Administrative Review Team

19-005ARB-MSP - STUDIO ON BRIDGE STREET HAIR SALON SIGN

Master Sign Plan for a new sign for an existing tenant with an existing wall sign located within Historic Dublin.

2) Details

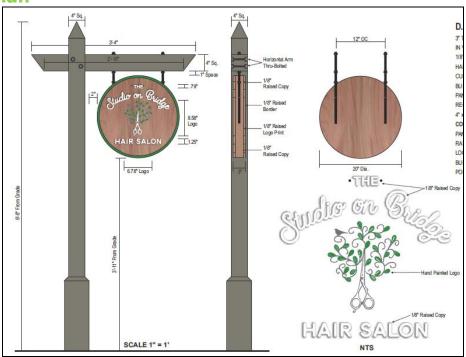
The Code permits ground signs within the Historic District to be a maximum of 8 square feet in size. A sign requested is within the permitted size. The sign is affixed to a 4-inch by 4-inch, 6'-8" tall wood post which is taller than Code permits. Staff is conditioning that the overall height of the sign, including the post, be reduced to 6-feet in height, which would meet Code requirements. The proposed height of 6'-8" is taller than the majority of the signs in the Historic District and does not match the character of similar signs surrounding the site.

Code limits the sign to three colors; however, the Master Sign Plan would permit flexibility for increased creativity including number of colors. The proposed sign includes four colors: a natural cedar panel for the background, green (PMS #2424) and white for the raised border and copy, and gray, green (PMS #2424) and white for the logo, as well as green (PMS #2424) for the bullet points.

<u>Criteria Met with Conditions</u>. The proposal permits additional flexibility allowing the applicant to keep an existing sign and to locate a new sign in a manner that is pedestrian oriented while realizing the need for wayfinding at a variety of scales. The applicant should revise plans to lower the overall height of the sign to meet the Code limitation.

1) The applicant lowers the overall height of the sign to 6-feet
